**PROPOSED SOCIAL WELFARE FACILITY (RESIDENTIAL CARE HOME FOR PERSONS WITH
DISABILITIES) IN "VILLAGE TYPE DEVELOPMENT" ZONE ON APPROVED NAM SANG WAI
OUTLINE ZONING PLAN NO. S/YL-NSW/10 AT LOTS 3669 S.A RP (PART), 3669 S.B RP (PART),
3670 RP (PART) AND ADJOINING GOVERNMENT LAND IN D.D.104, NAM SANG WAI, YUEN LONG**

Town Planning Application No. A/YL-NSW/348 - Submission of Further Information (4)

Response-to-Comment Table

Drawing No. D1199/KP/LW/015	Stage	Rev. Z
--------------------------------	-------	-----------

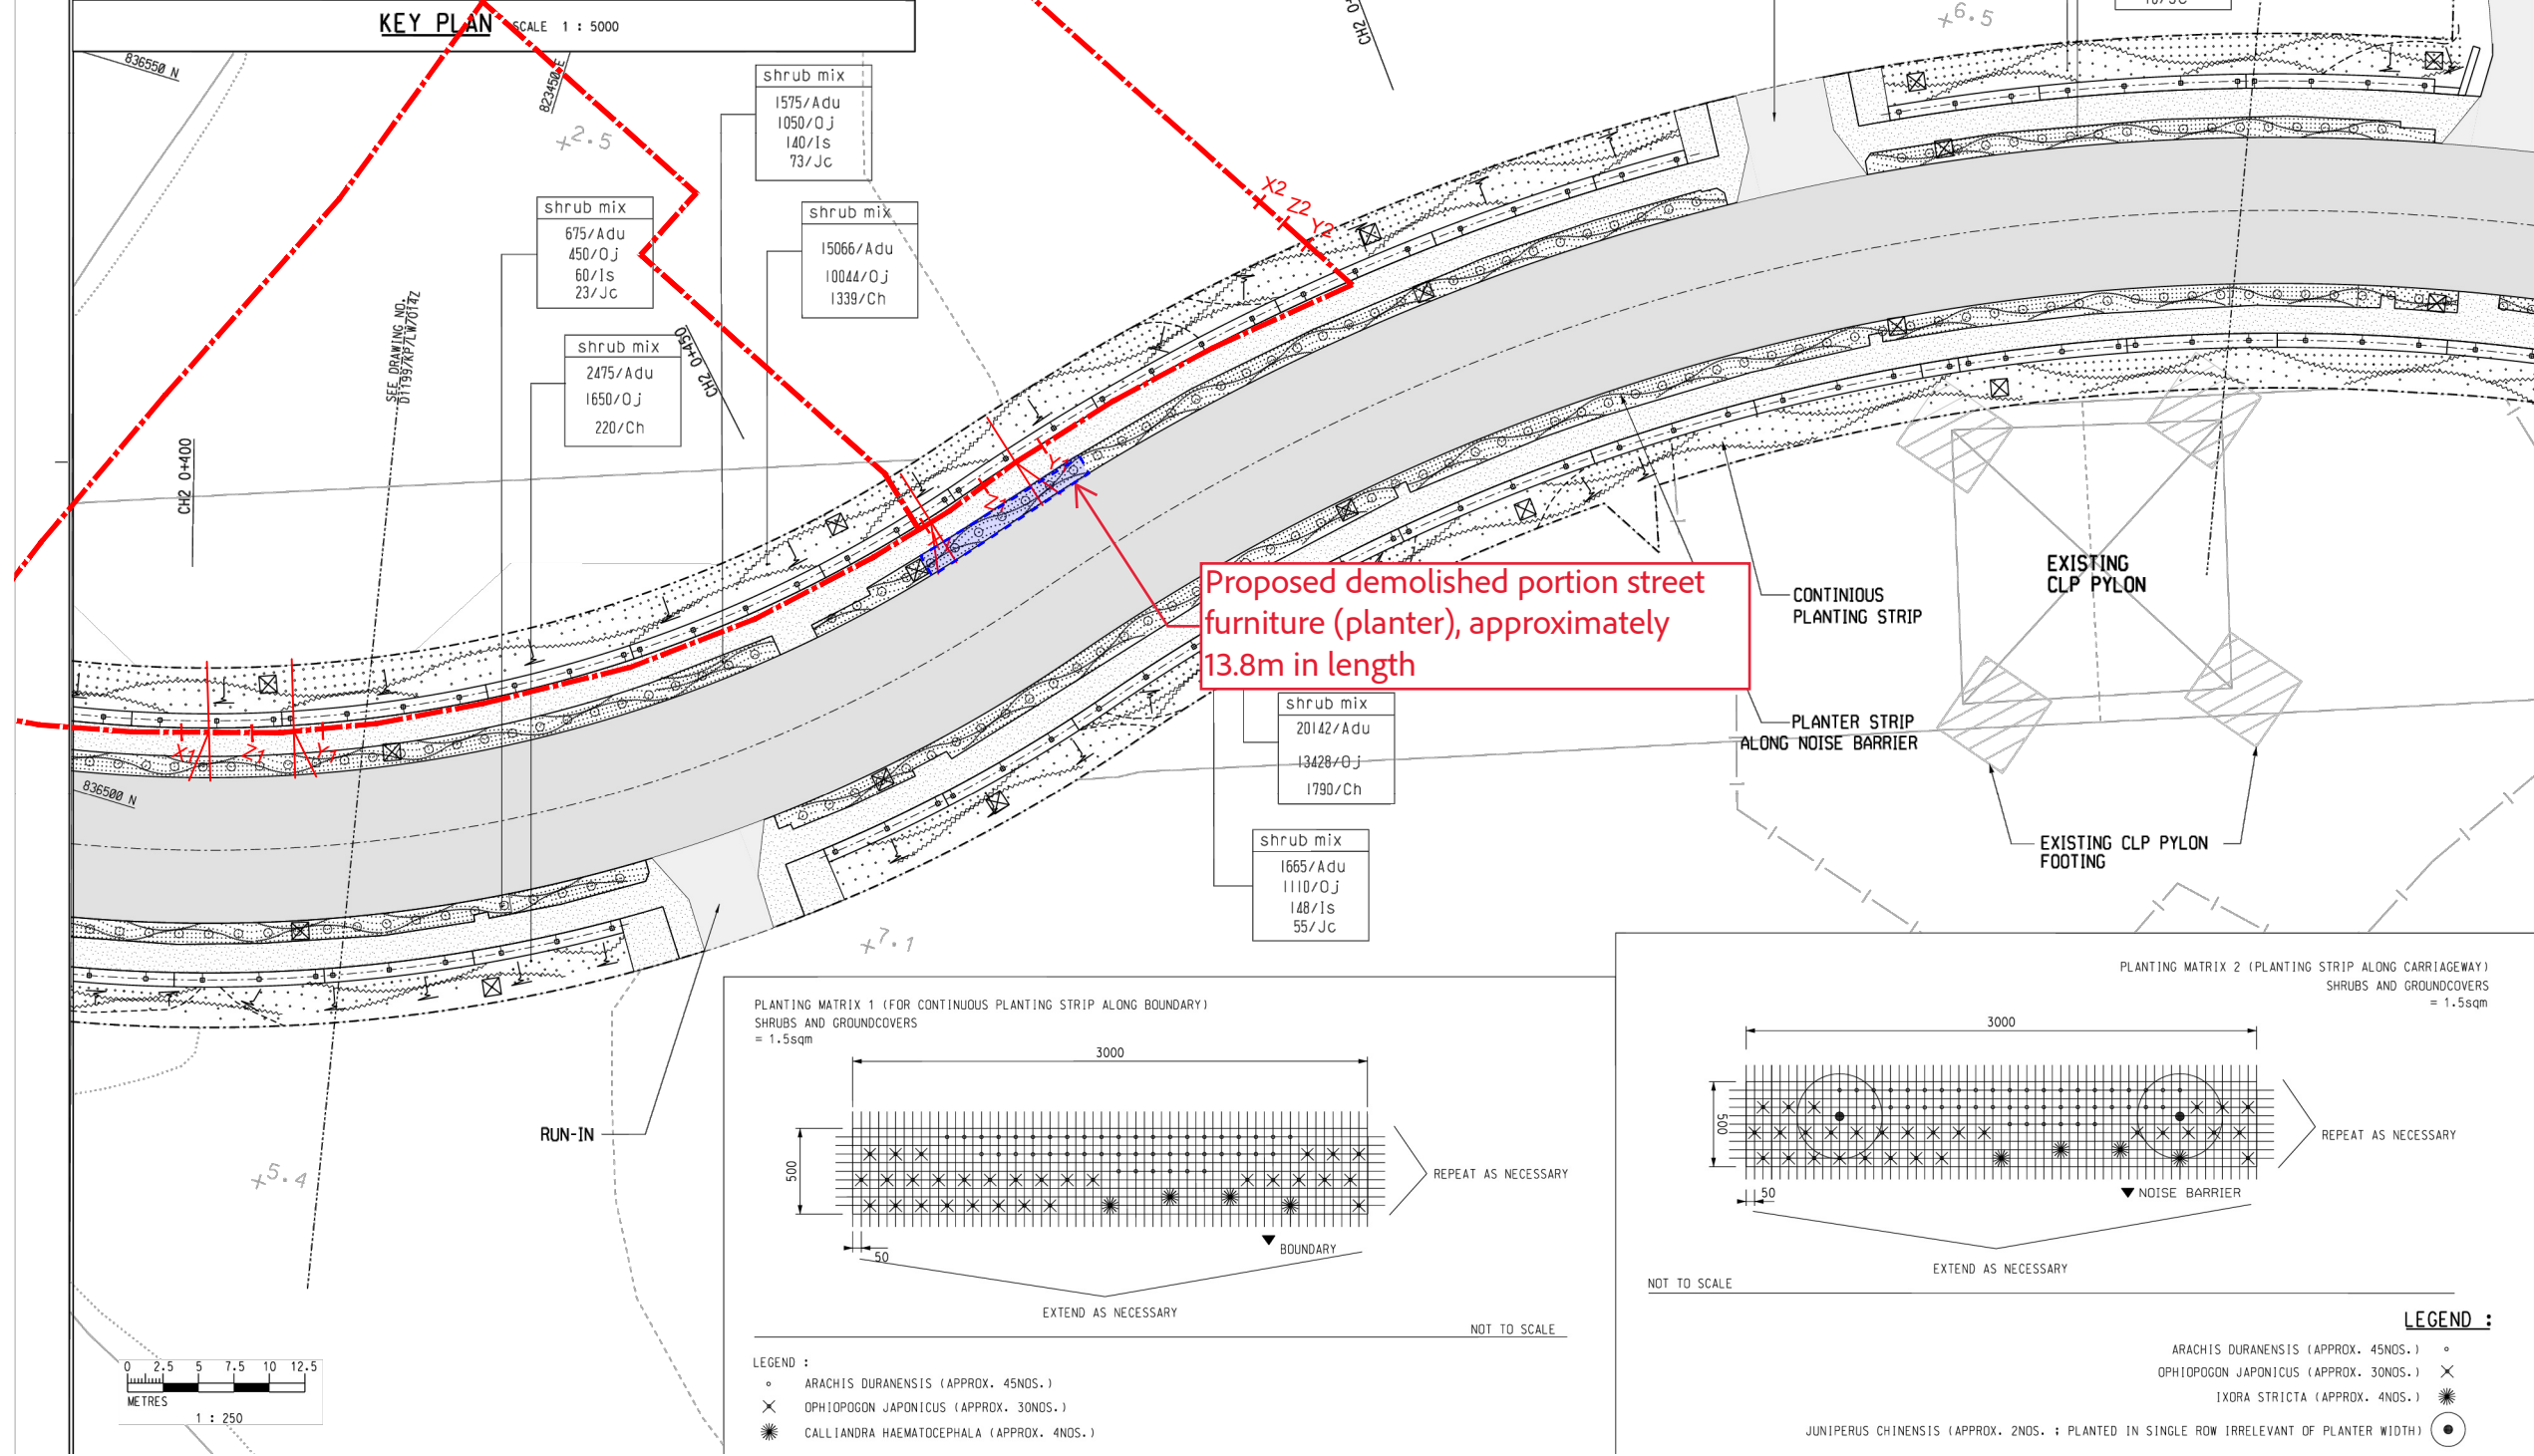
(a) The relevant portions of noise barriers proposed to be removed have not been clearly indicated or marked on the modification plan. Please clarify.	Please refer to Appendix 1 for the Modification Plans of Noise Barrier and Street Furniture.

FIGURE 3.1
LOCATION OF REPRESENTATIVE NOISE
SENSITIVE RECEIVERS

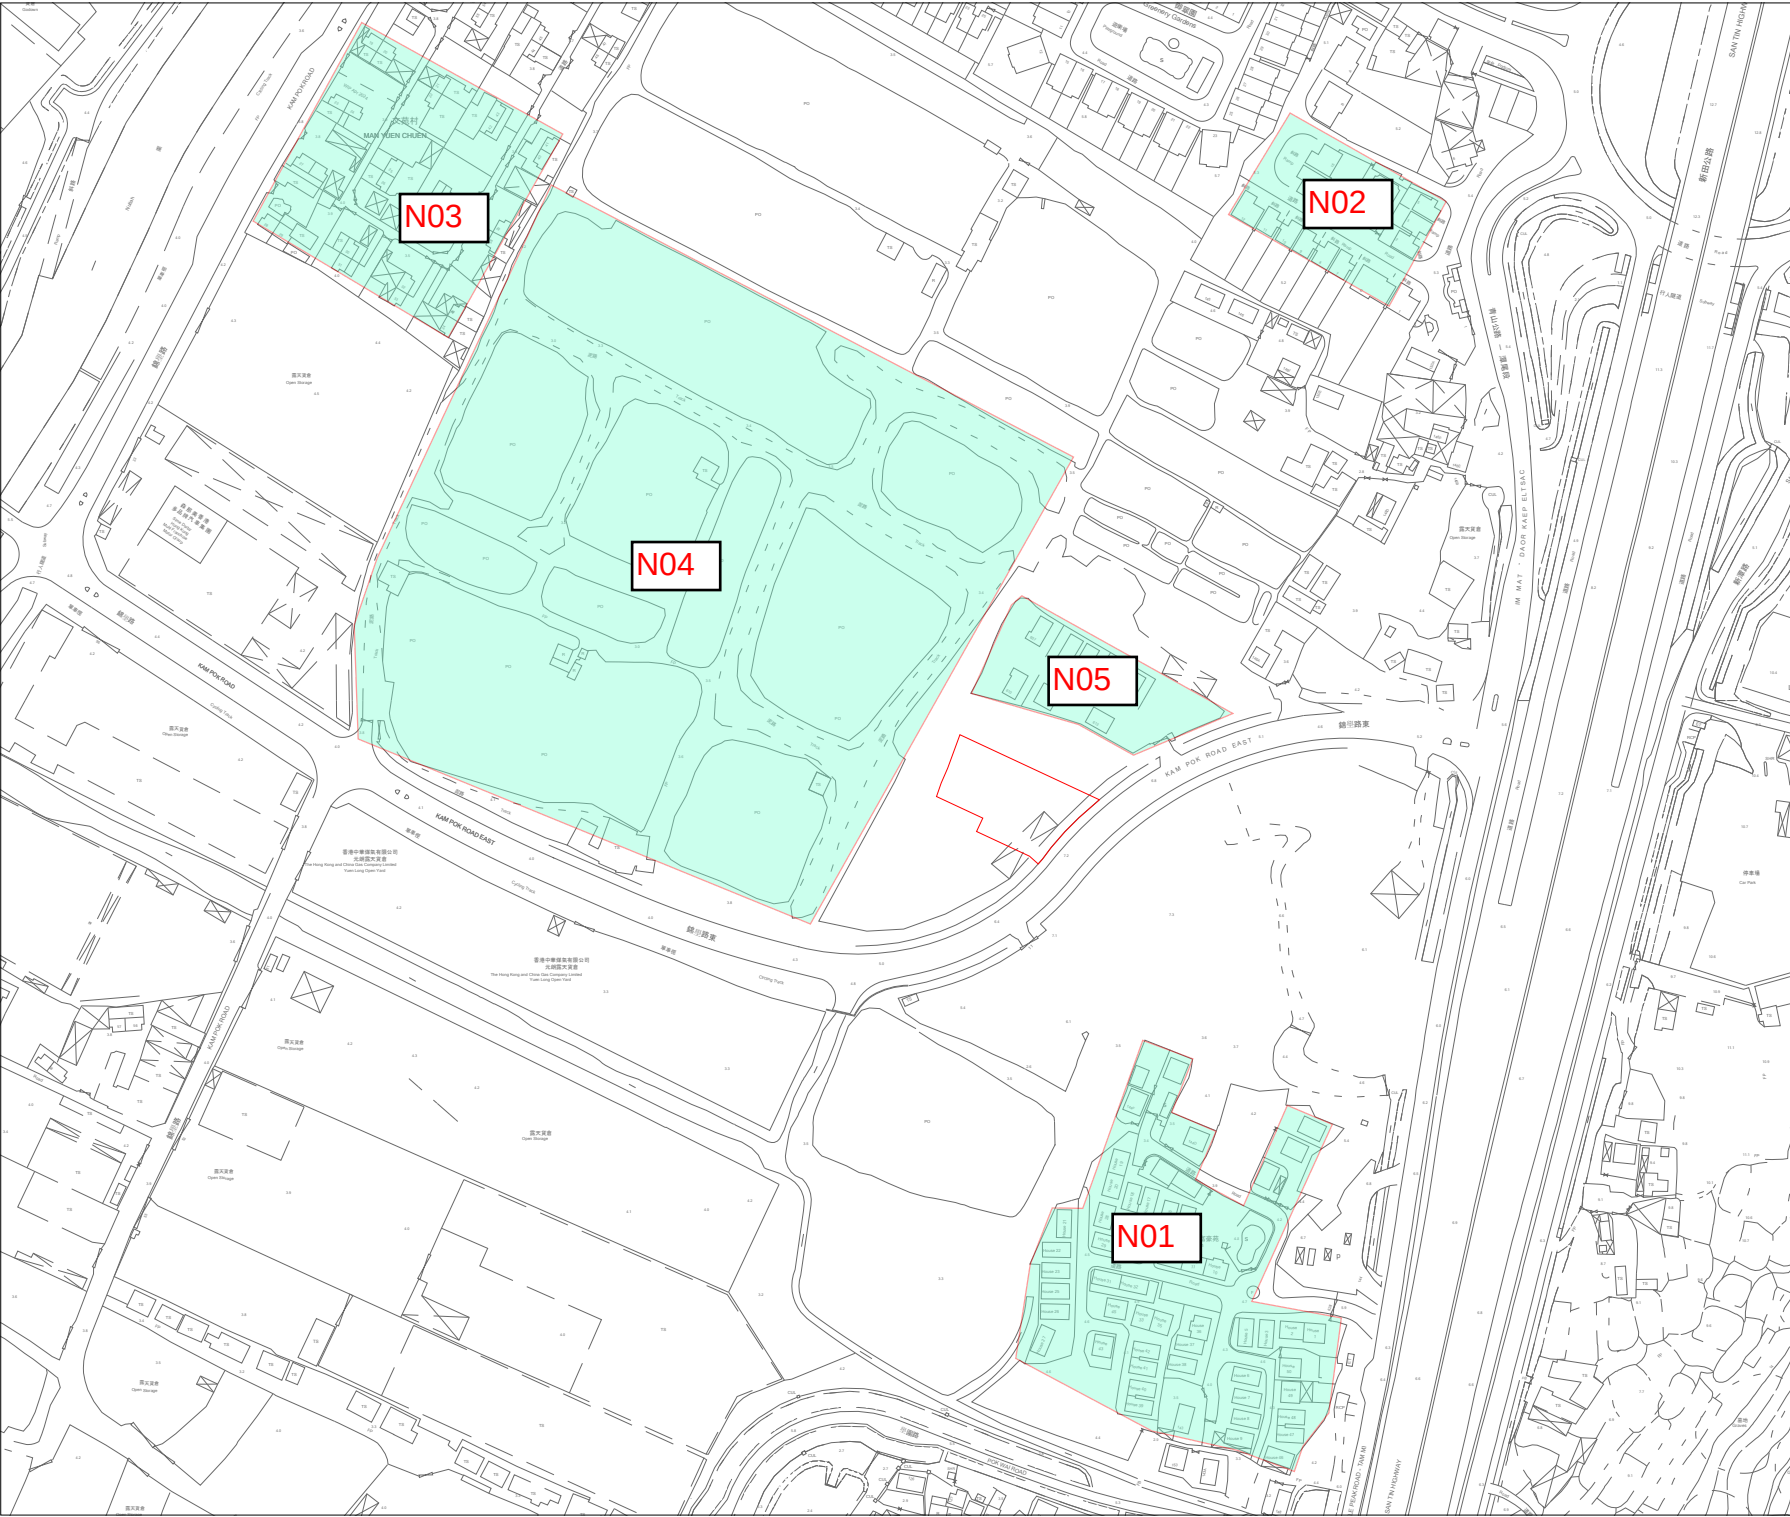
Email dated 7th November 2025 refers: <u>Comment from EPD</u>	Response
General 1. Please highlight/indicate all changes for ease of review.	Noted. Please refer to Appendix 4 for the Revised Environmental Assessment.
Air Quality 1. Please revise the reference error in S.2.4.2	The error has been revised accordingly.
Noise 1. Please review whether the structures in the immediate north of the Site are NSRs.	New NSR is added in Table 3.5 and Figure 3.1.

Drawing No. D1199/KP/NB/011	Stage	Rev. Z
---------------------------------------	-------	------------------

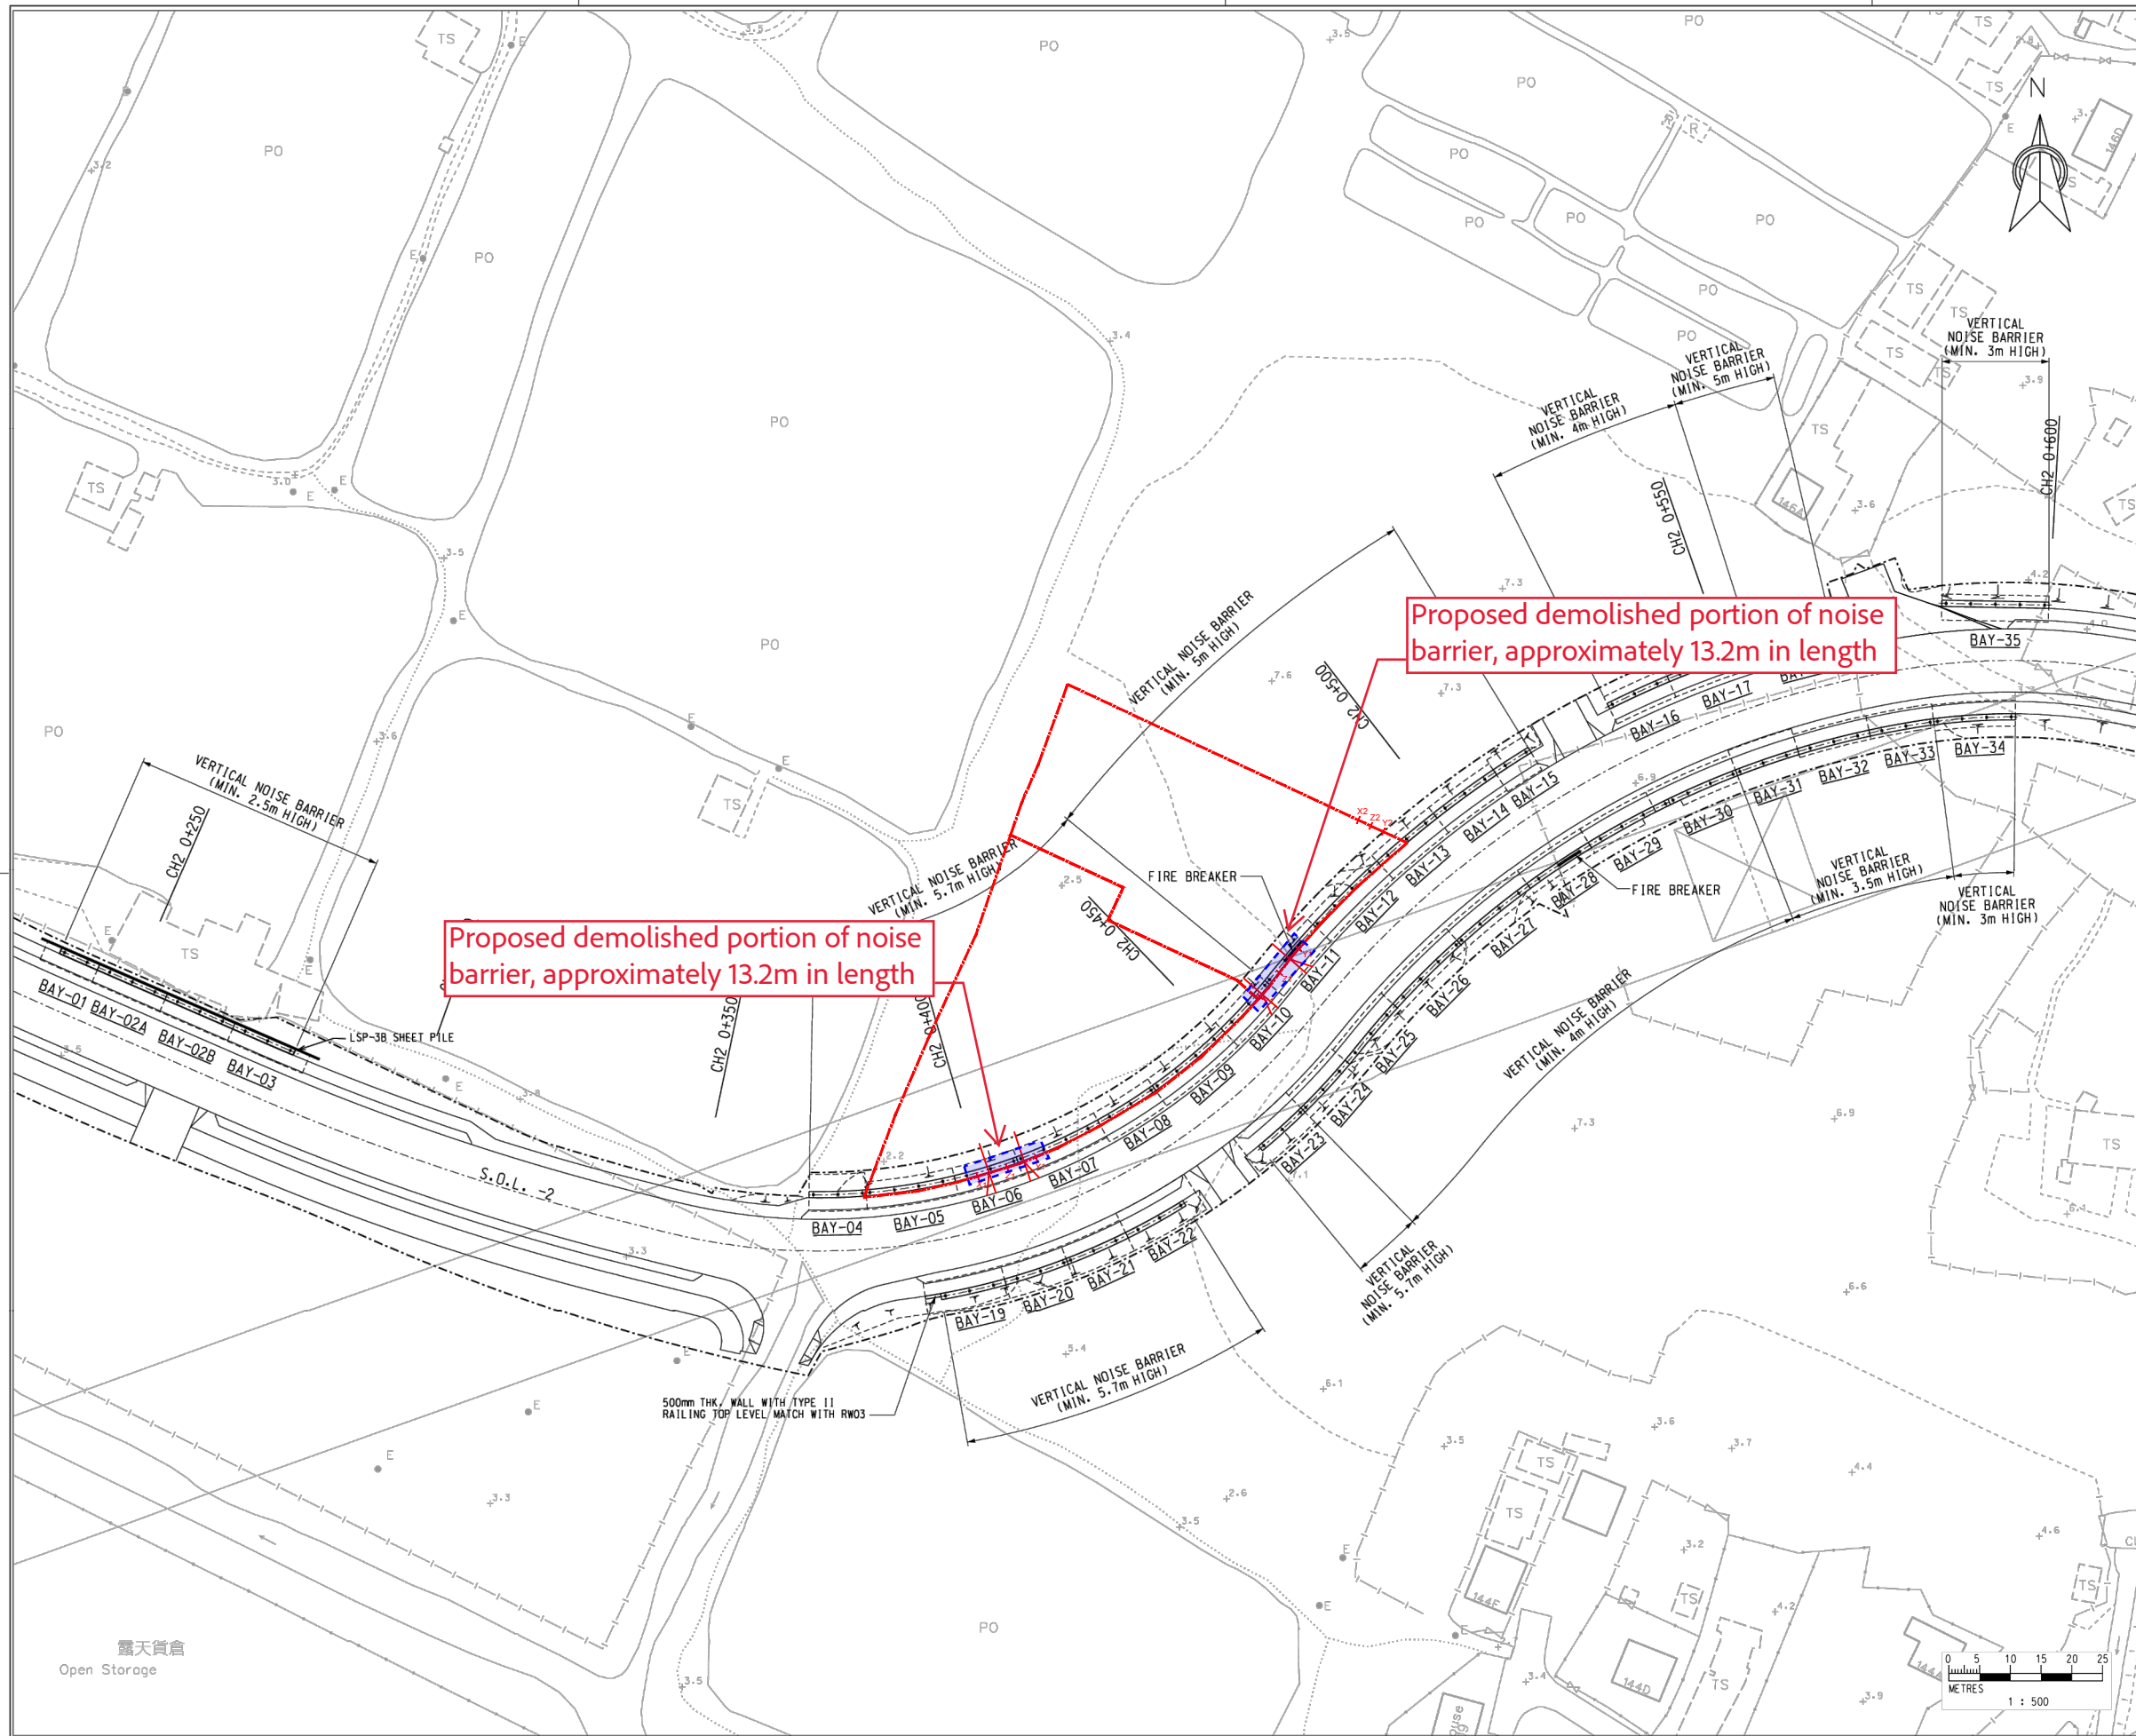
10. Last RtC item 3 in Comments on road traffic noise model i. Please explain if “EVA” stands for emergency vehicle access. ii. For the proposal to remove a portion of the noise barrier for the entrance for EVA, please confirm if this has been discussed with the relevant authority. Additionally, please document this communication.	Yes, “EVA” stands for emergency vehicle access. In relation to the Traffic Impact Assessment and comments from Highways Development, the proposed removal of noise barrier is submitted for comment, the information is provided in S3.4.7. Details of modification please refer to Appendix 3.5.

2. Please check and ensure the site boundary of A/YL/NSW/348 and A/YL/NSW/349 does not overlap in the model.	Noted.
3. There are breaks on the noise barrier in the model, please check, and revise if needed.	Refer to building plan in Appendix, part of the noise barrier will be removed for entrance of EVA.
